Detailed Site Plan

Behnke Property 7-Eleven

DSP-20029

SUBJECT: Detailed Site Plan DSP-20029
Behnke Property 7-Eleven

Figure 1: Site Development Plan

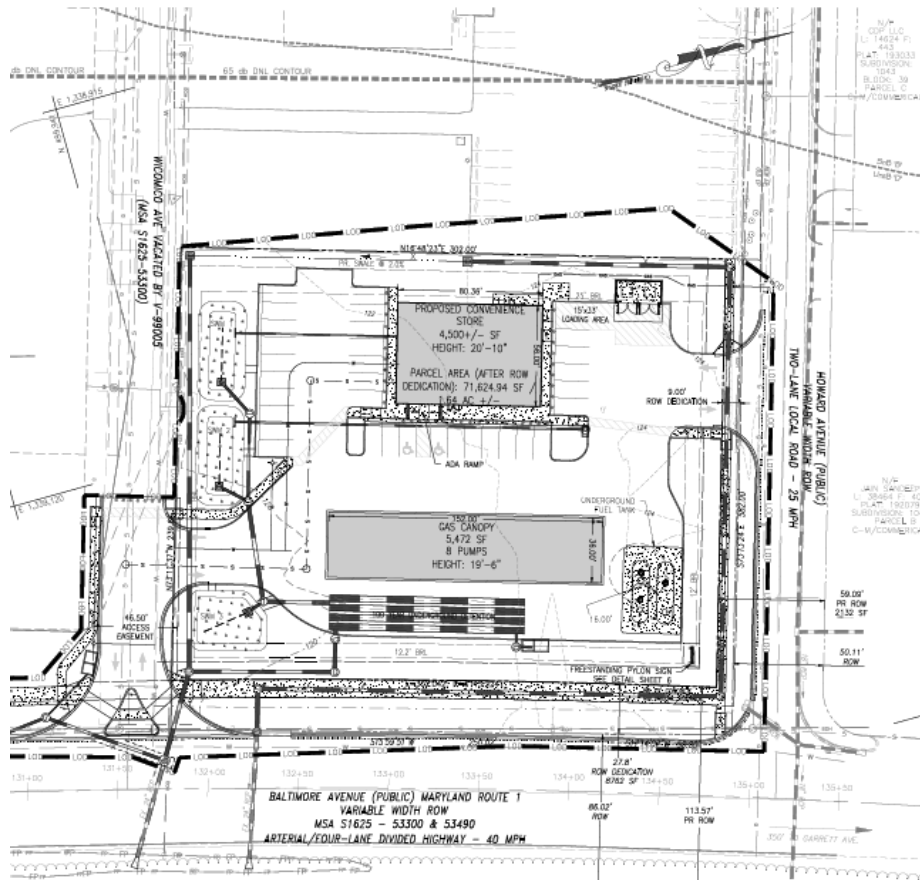
- 1. Prior to certification, the detailed site plan (DSP) shall be revised, or additional information shall be provided, as follows:
 - a. Ensure the proposed public utility easement along Howard Avenue is not interrupted by the driveway entrance to the site from that street.
 - b. Revise signage tables to include area calculations for all proposed signage to show conformance with Section 27-613(c) and Section 27-614(c) of the Prince George’s County Zoning Ordinance.

- c. Remove the two freestanding directional signs, as only one freestanding sign is allowed, per Section 27-614(d) of the Prince George's County Zoning Ordinance.
- d. Revise the parking schedule to include parking requirement calculations. Correct the parking schedule to show 32 spaces are provided, as shown on the DSP.
- e. Provide a continental style crosswalk at the site access easement driveway along US 1 (Baltimore Avenue).
- f. Provide a continental style crosswalk at the site driveway entrance along Howard Avenue.

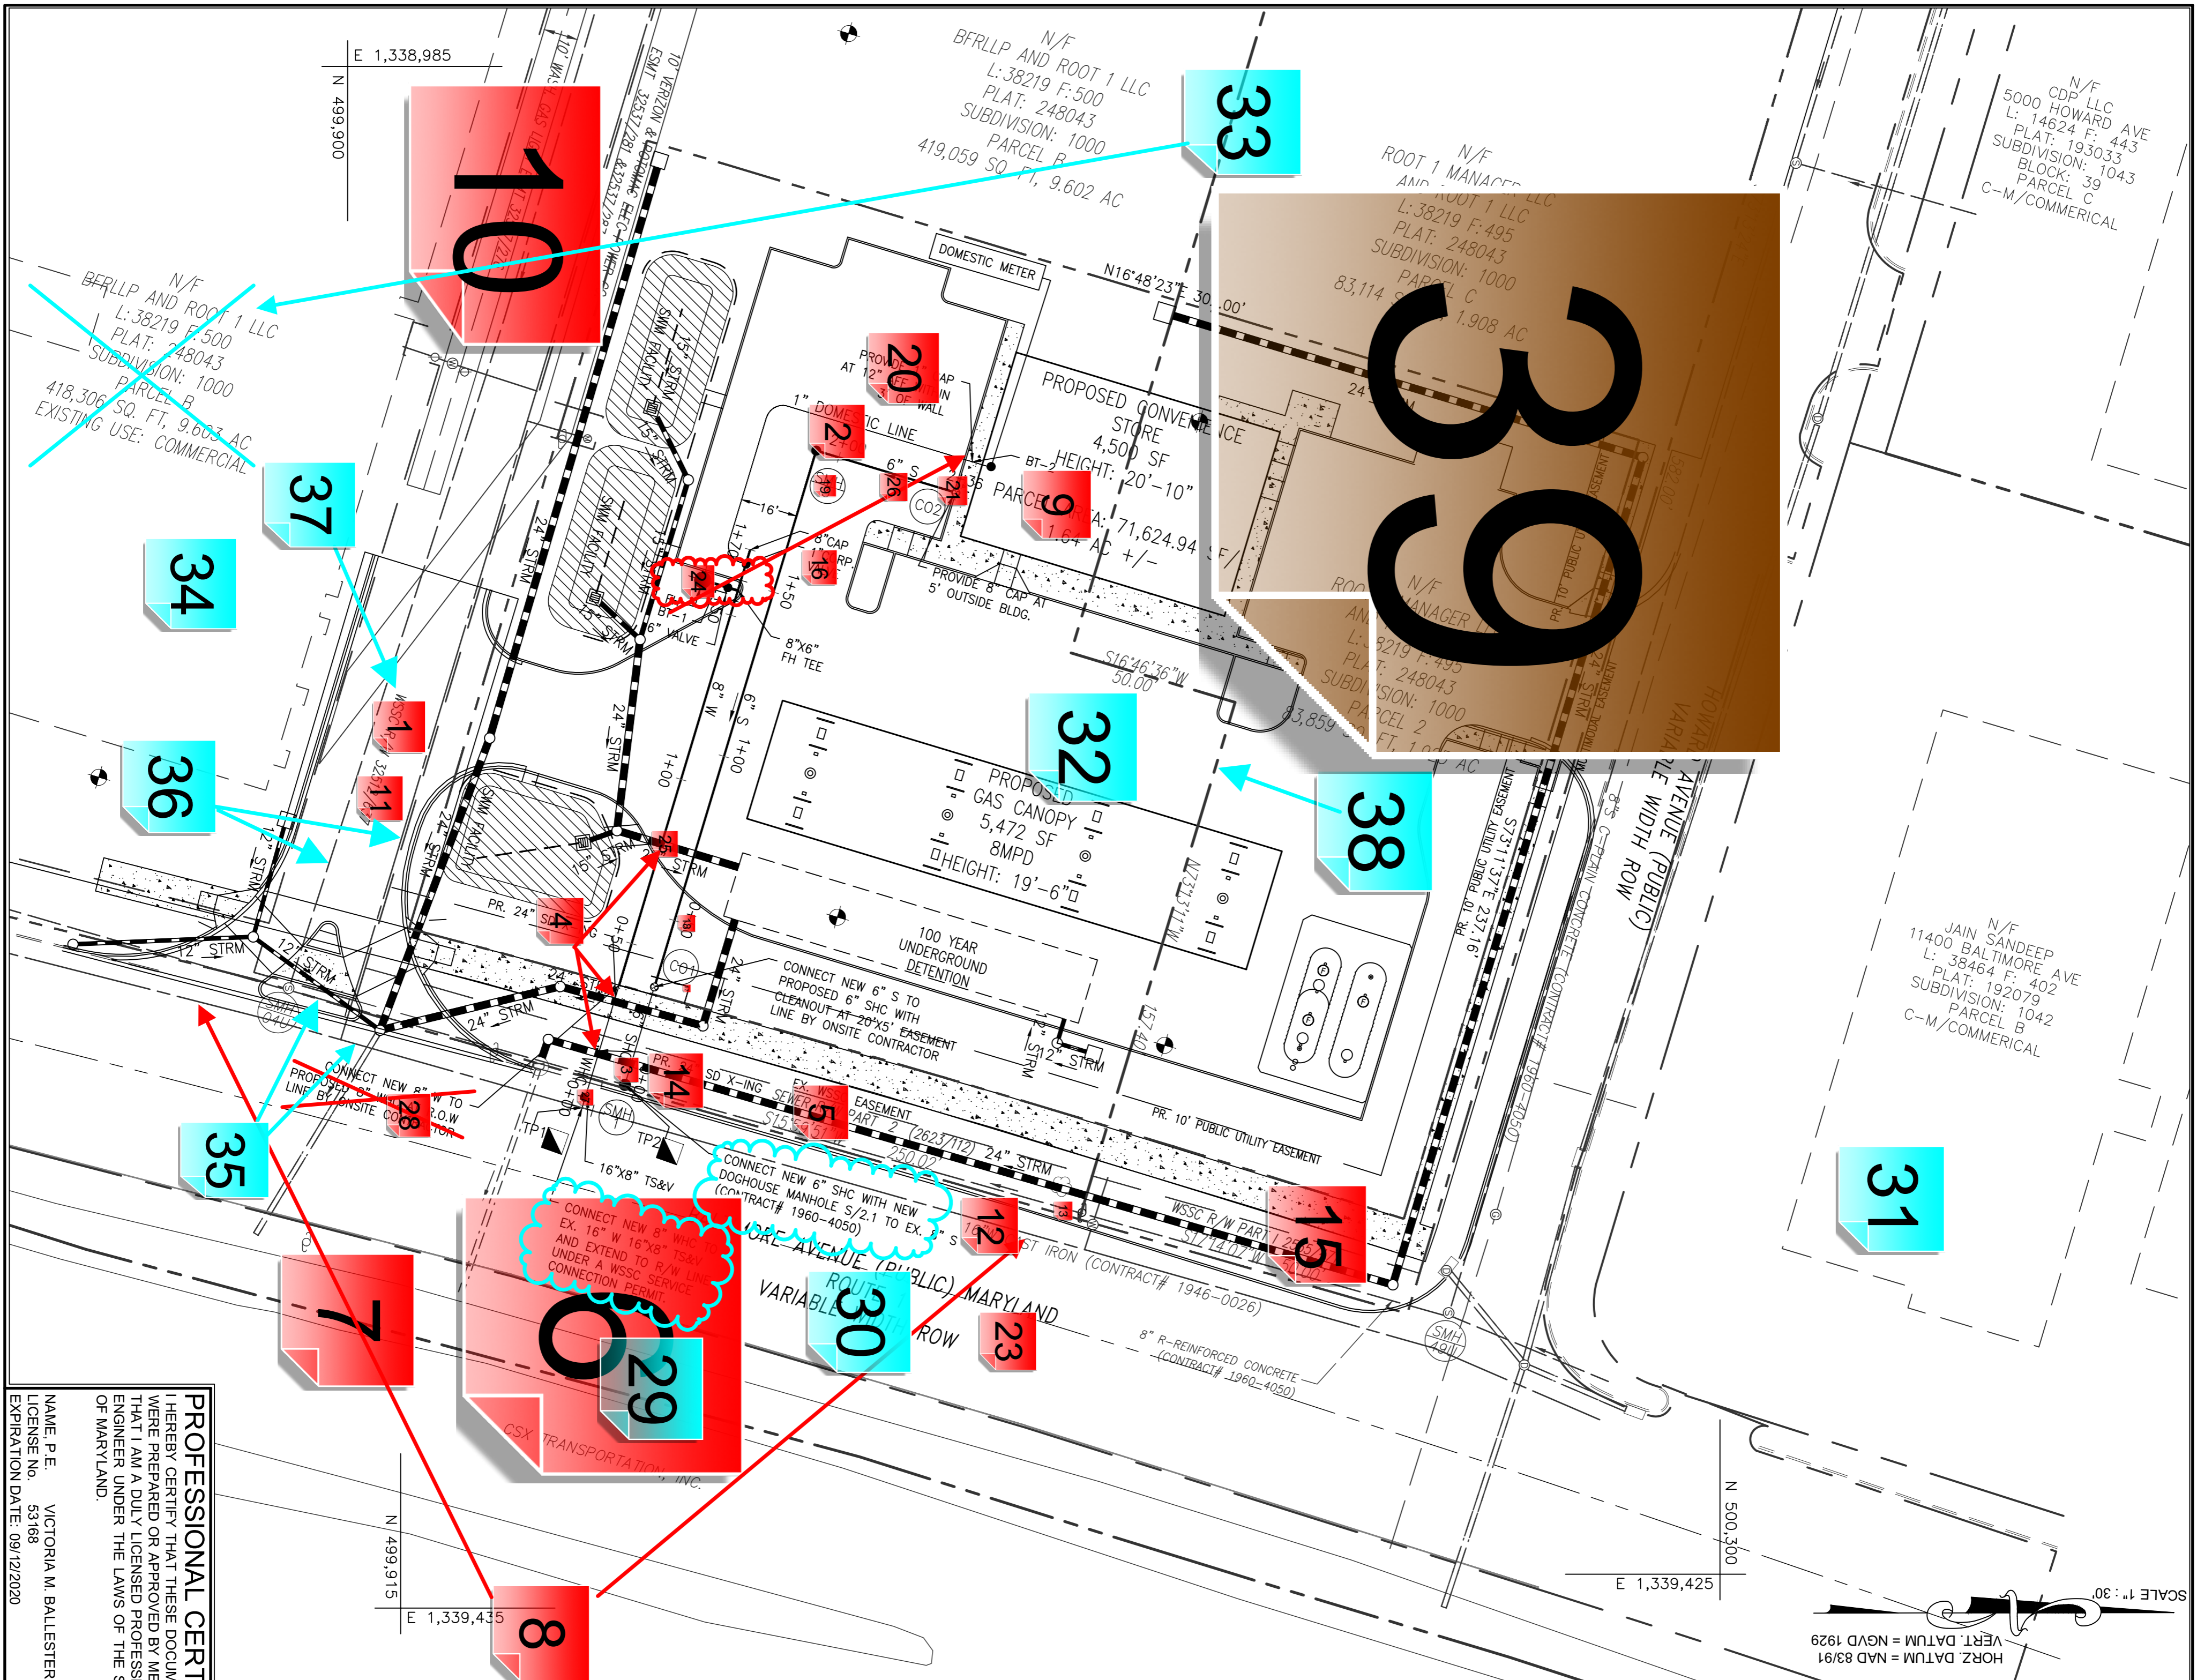
Insufficient clearance between water and storm. Minimum 1', outside of pipe/structure to outside of pipe/structure is required.

39 - Changemark #02

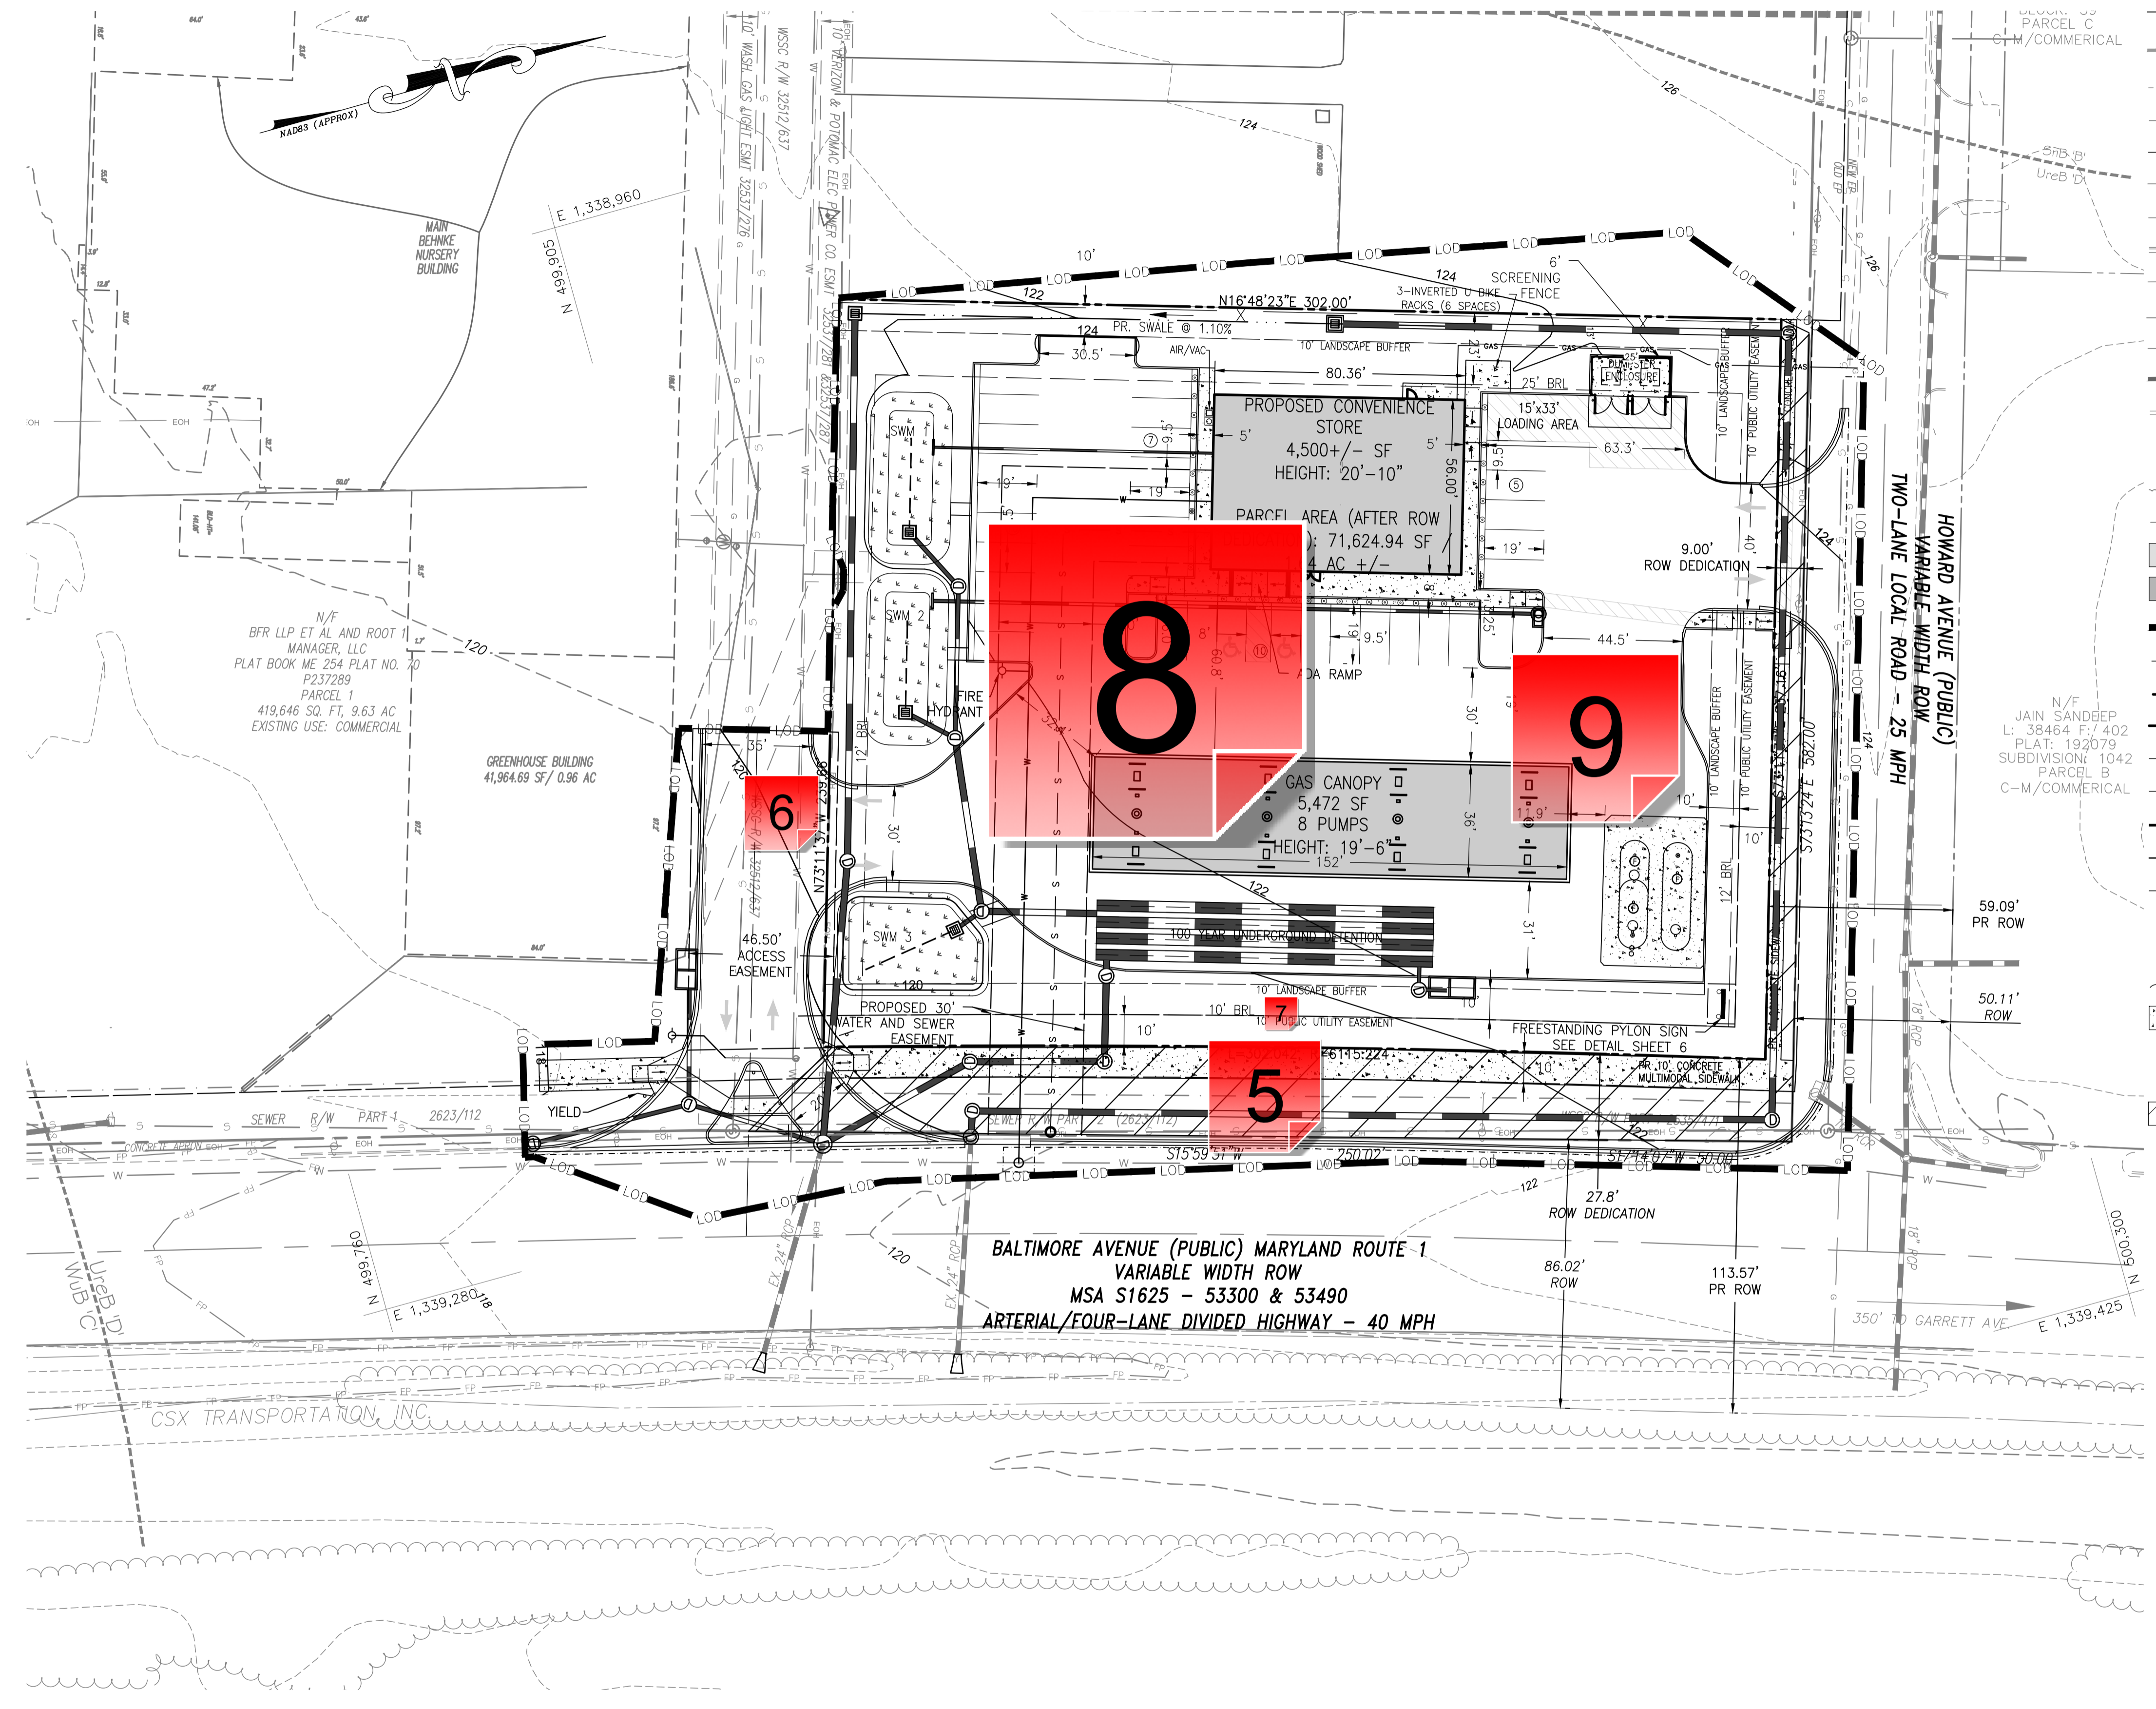
Remove old property line and label according to recorder to plat. Must match the plan. Please remove old property lines as this is Parcel 1 and Parcel 2.
